Spur Hill Underground Coking Coal Project
Technical Report Accompanying A Gateway Certificate

19 March 2014

FIGURE 2. Verified BSAL within the Project Area (SHM, 2013)

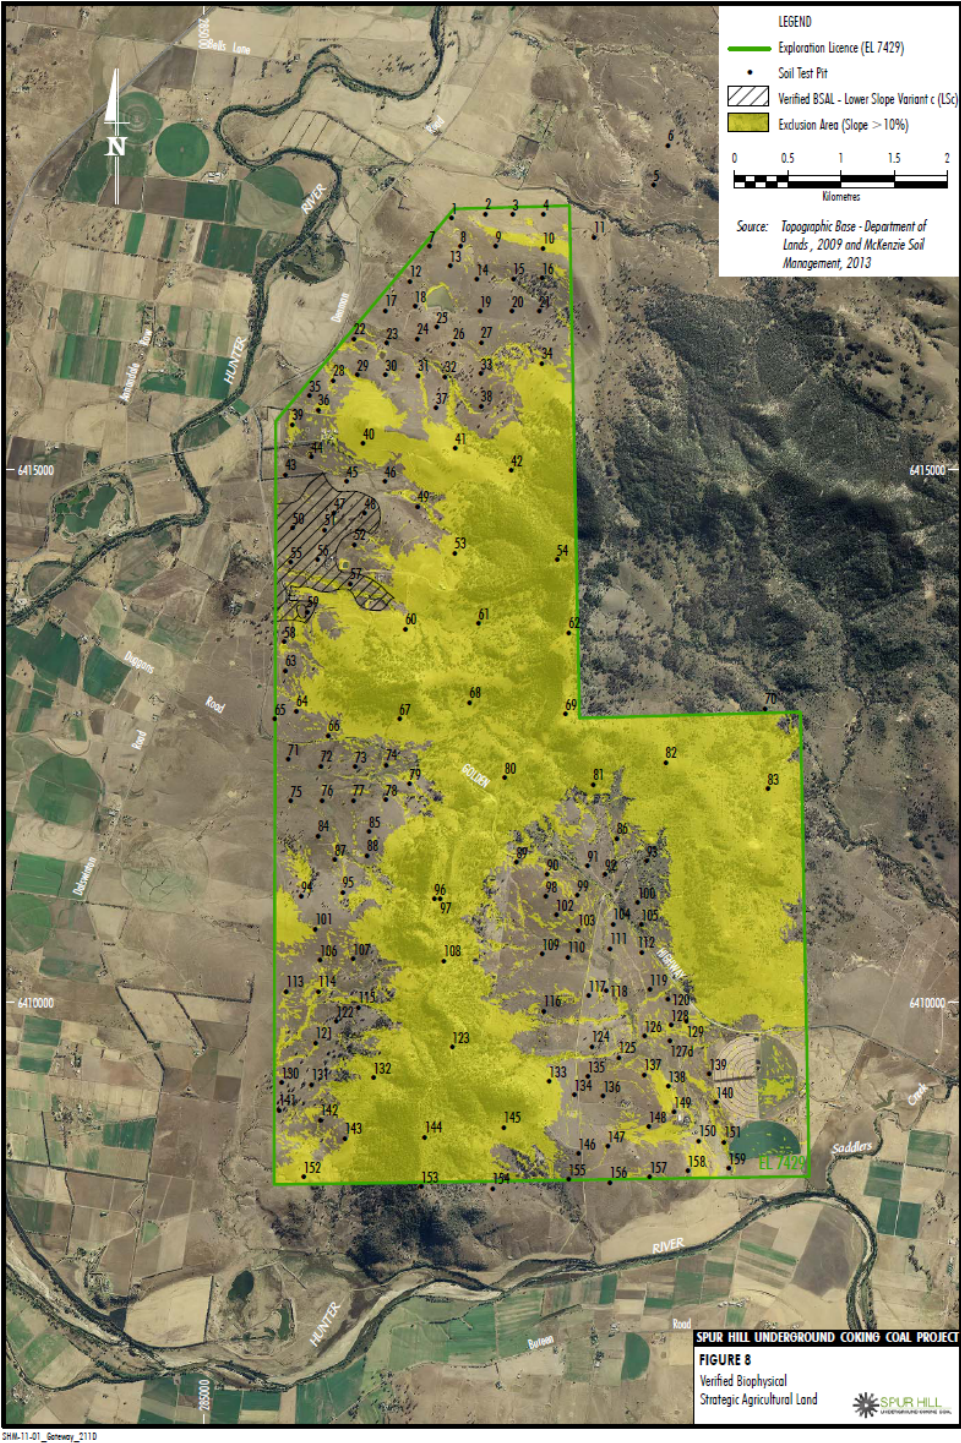
One of these sites (soil pit 139) is on the south-eastern edge of the soil survey boundary (see Figure 2) and borders a substantial section of the *project exploration licence area* (EL7429) that was not physically surveyed in the ARA (McKenzie, 2013). This area, which is identified in Figure 4, has had the land and soil capability mapped using archival regional-scale landscape mapping only.

The only area of identified and verified BSAL within the Project area (see Figure 2) is not understood to be associated with any of the proposed surface works or other mine infrastructure that would cause it to be either removed or temporarily disturbed by such works.

- (a) That BSAL be identified and verified within the entire Project area, particularly in the south-eastern corner which is located in close proximity to the Hunter River and associated alluvium. Once all such BSAL has been identified and verified, it should be evaluated for mining impacts accordingly.

FIGURE 3. Agricultural Land Use (SHM, 2013)

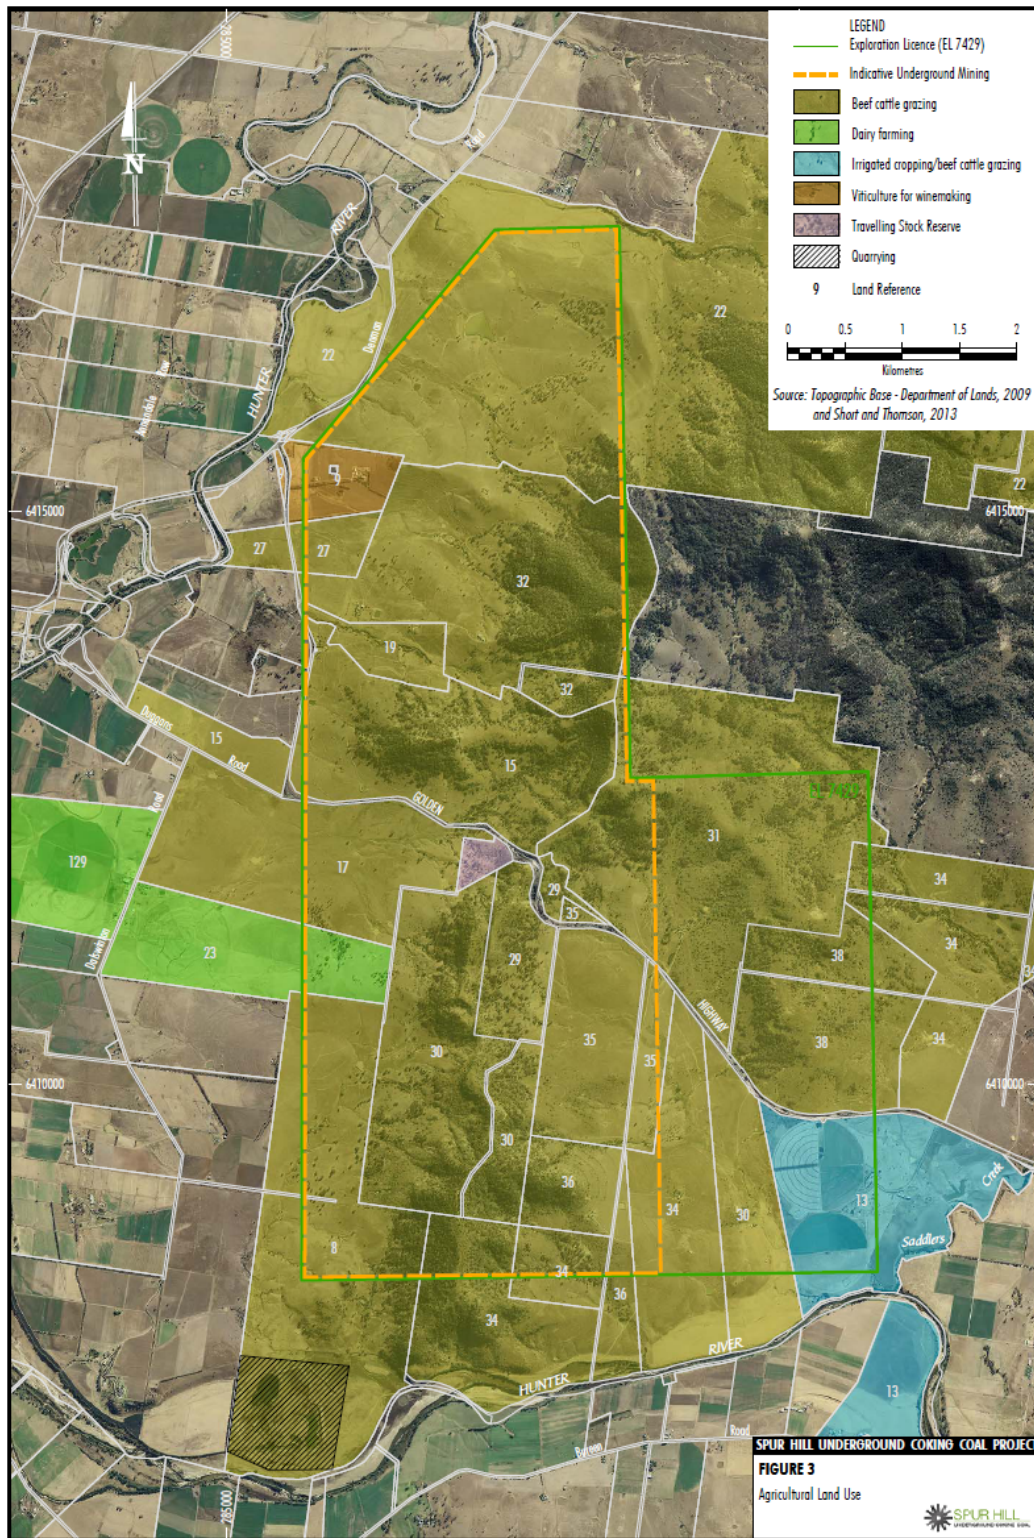
Similarly, the single vineyard that is part of the Upper Hunter Viticulture CIC (see property 9 on Figure 3), which does not coincide with the verified BSAL, is not associated with any of the proposed surface works or other mine infrastructure. Therefore the Project does not intend to either permanently remove or temporarily disturb this CIC component.

- (j) Provide details of a suitable management plan for irrigation infrastructure on the Callatoota Estate vineyard when impacted by mining subsidence.

FIGURE 6. Predicted Shallow and Deep Far-field Groundwater Changes due to Mining (HydroSimulations, 2013)

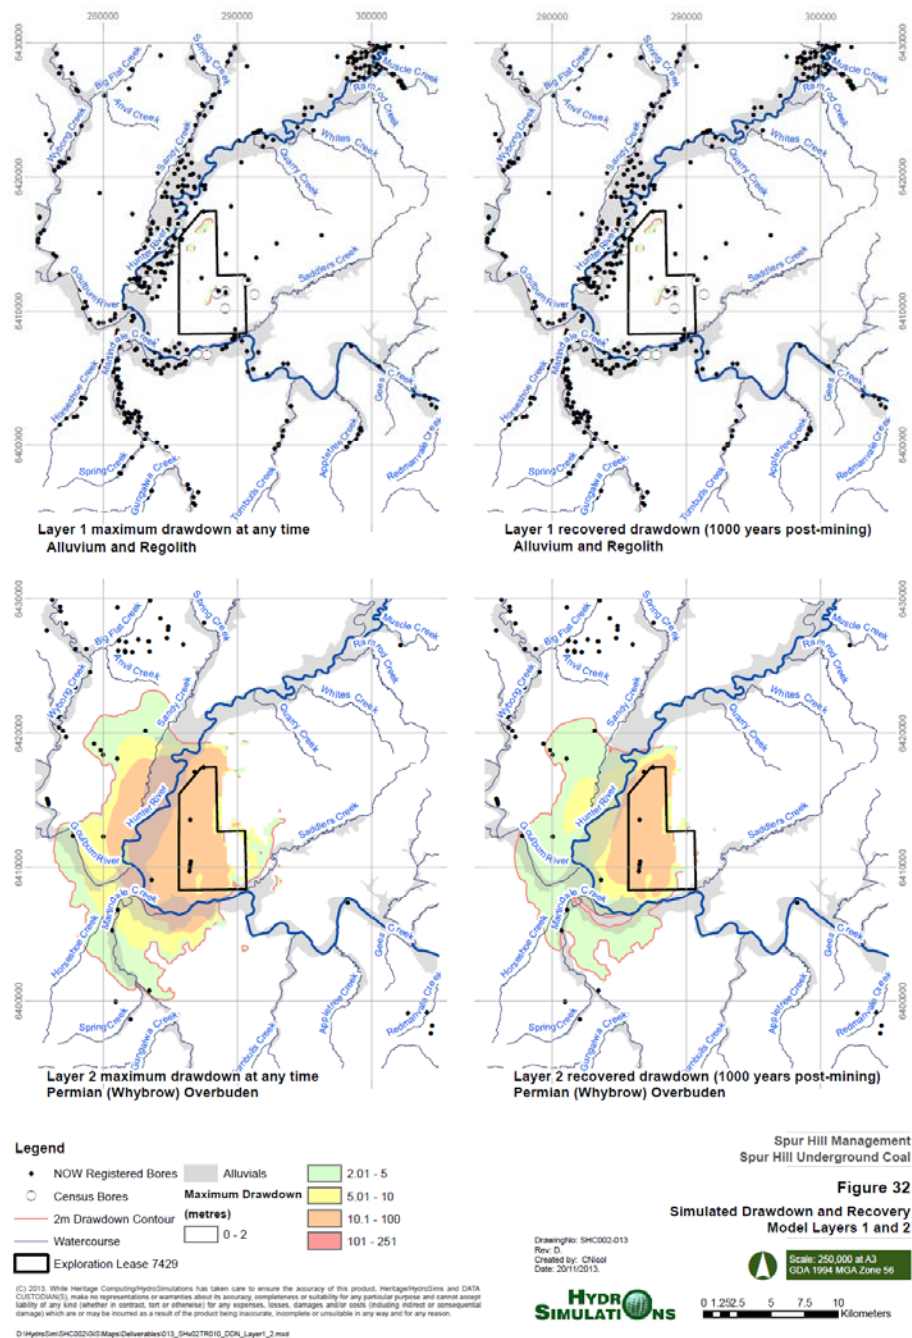
3. The Report indicates that significant groundwater changes occur out to 7km from the lease boundary (e.g. Figure 32 reproduced herein as Figure 6) for some of the deeper layers of the model (hereafter referred to as the broader impact zone). However, the Report has not addressed the risk of interconnection between these deeper layers and the surface. Both the IESC and NSW Office for Water advice reports indicate concerns about potential interconnection between the deeper layers and the surface and between the deeper layers and other aquifers covered by the groundwater sharing plan. The IESC has also identified the possibility of potential impacts on BSAL land in this broader impact zone. Explicit

consideration is required of the potential for interconnection between groundwater layers, and the potential impact of such interconnection. Any such interconnection (currently unrecognised in the modelling) might conceivably result from unmapped faults and dykes, but also from any significant inaccuracies in the definition of lithology in the deep geology maps for the broader impact zone.
